### URGENT FIELD SAFETY NOTICE

Product Name: **Alaris™ / Asena™ GS, GH, CC, TIVA, PK, Enteral Syringe Pump**  
Product codes with prefix (all variants): **8001, 8002, 8003, 8004, 8005, 8007**  
FSCA Identifier: **RA-2018-03-01**  
Date: **May 2018**  
Type of Action: **Field Safety Notice**

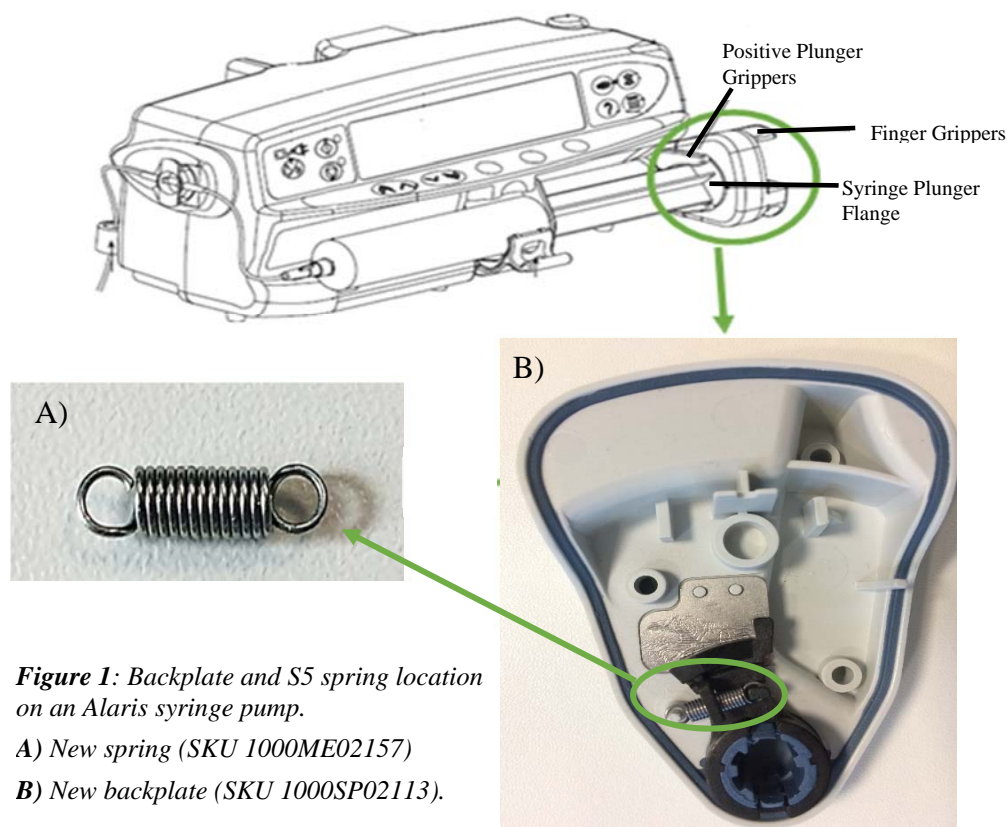
BD is undertaking a corrective action on its Alaris™ / Asena™ syringe pumps to replace the existing gripper plate actuating spring (S5) design with a new improved design, which is located on the back-plate of the syringe plunger holder as shown in Figure 1 A) and B). This is being undertaken to improve performance and reliability of the S5 spring to reduce the risk of harm to patients. This corrective action supersedes the Alaris™ / Asena™ syringe pump S5 spring replacement, FSN RA-2017-02-02, issued in March 2017.

The S5 spring is located on the back-plate of the syringe plunger holder and ensures that the syringe plunger flange sits tightly between the positive plunger gripper and the back-plate.

BD has identified that the gripper plate actuating spring (S5), can break and may prevent the gripper fingers from securing the syringe plunger within the plunger holder mechanism which causes a small gap between the syringe plunger flange and the syringe drive mechanism. See Figure 1.
